STAFF REPORT
DATE: 12/3/2024
REGULAR AGENDA

TO: City Council
FROM: Nathan Fuerst, AICP, Consulting Planner
AGENDA ITEM: **Discussion Only – Limerick Village Sketch Plan Review**
REVIEWED BY: Jason Stopa, Community Development Director

MEMORANDUM

RE: Limerick Village Sketch Plan Review

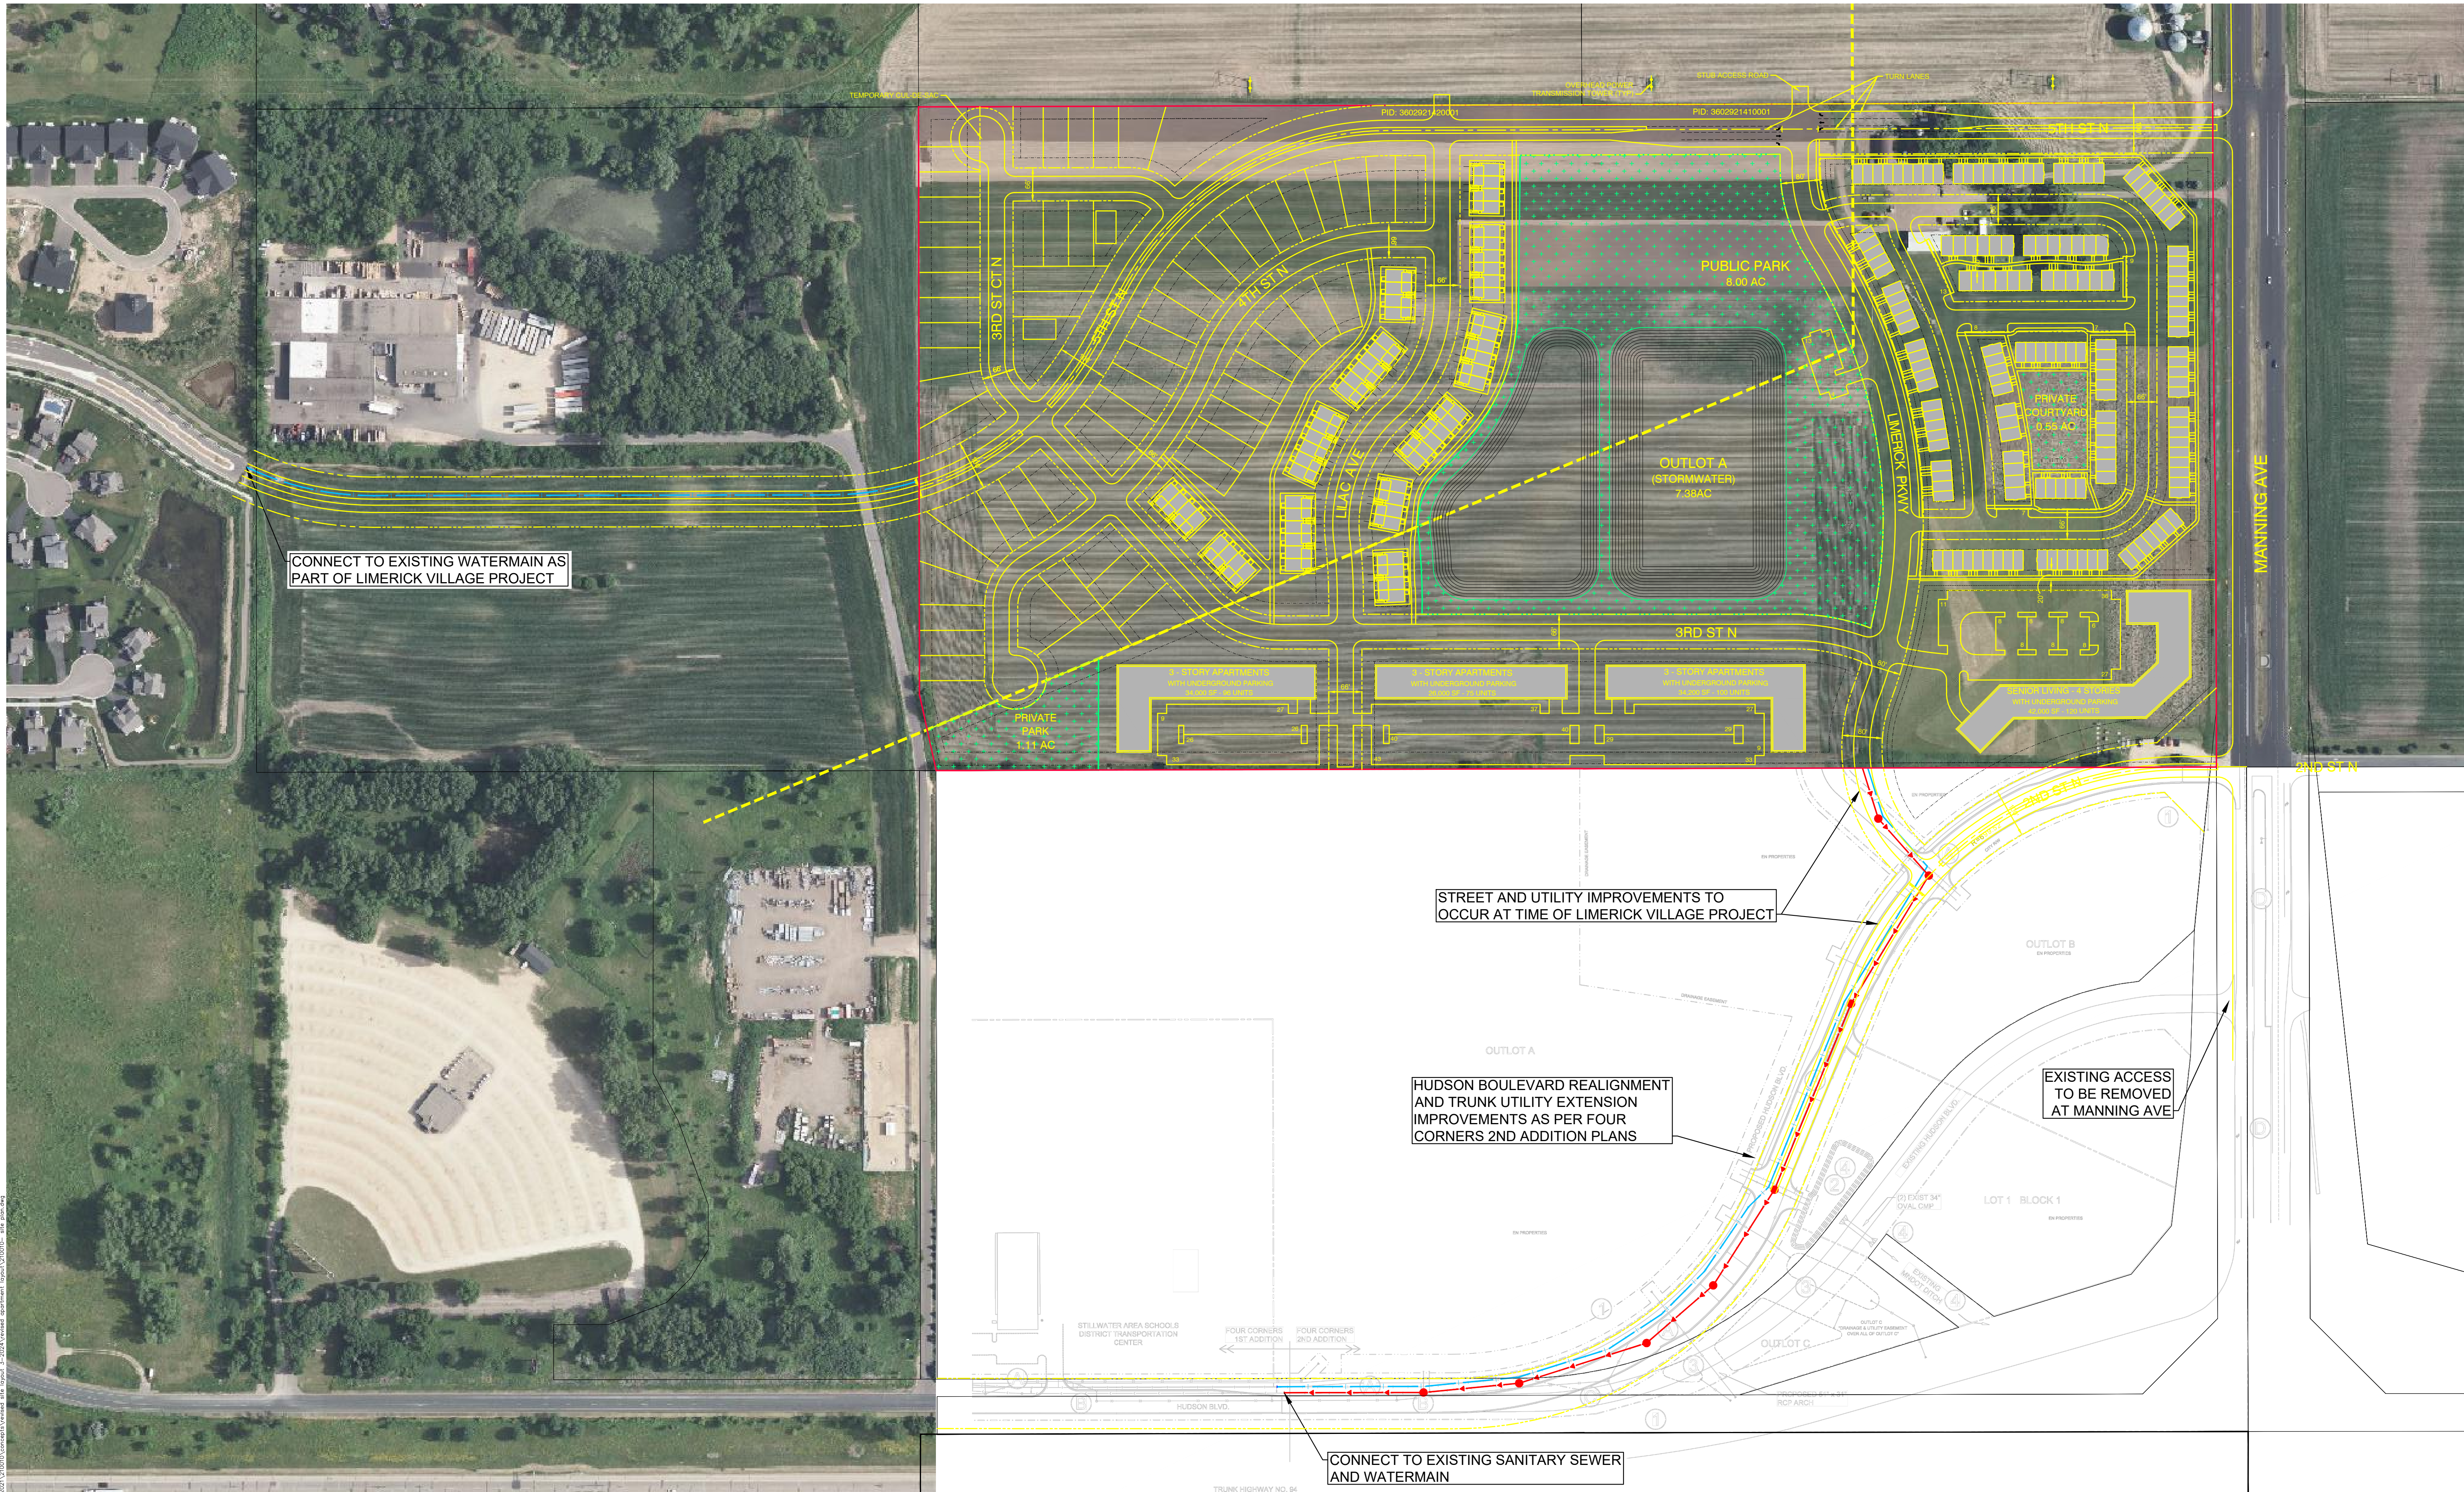
1. ~~3rd St N should connect to 5th St N.~~
2. ~~The single family lots should meet the minimum lot width of 50'. It is understood that density is a challenge. As indicated, the Developer can consider a comprehensive plan amendment to change the location(s) (but not totals) of the MDR/HDR areas. Alternatively, Developer can consider the location of apartments/attached units within the MDR area.~~
3. ~~The parking for the 3-story apartments should be behind the building abutting the parcel to the south.~~
4. ~~The parking for the senior living facility should be side or rear loaded. Parking should be screened from Limerick Pkwy.~~
5. It's noted that the northeast corner has changed from 20-unit rentals to attached townhomes. The townhomes should be double fronted, and rear loaded on public streets.

- a. Although townhomes are assumed to be double fronted in the NE corner of the development, this comment will remain until sidewalks or elevations are provided to substantiate design.

6. ~~Park B should be considered private open space with amenities to serve apartment residents. City will not accept two noncontiguous parks.~~
7. ~~As previously communicated, no units can be split by the boundary separating MDR and HDR. Met council staff were willing to overlook the minor discrepancy on future land use boundary because units were not impacted, and ROW was located in the hatched area. A Comp Plan Amendment could be required for the westernmost attached townhome to be located in that area. City staff would need to confirm with Met Council.~~

8. Townhomes along Lilac Avenue are added and should be designed consistent with LEC 105.12.740(g). City Code requires these units to be rear loaded. The units should all front on a public trail.

9. Two access points for 3-story apartment unit parking areas on Lilac Ave should be consolidated into just one access on either side of the street.
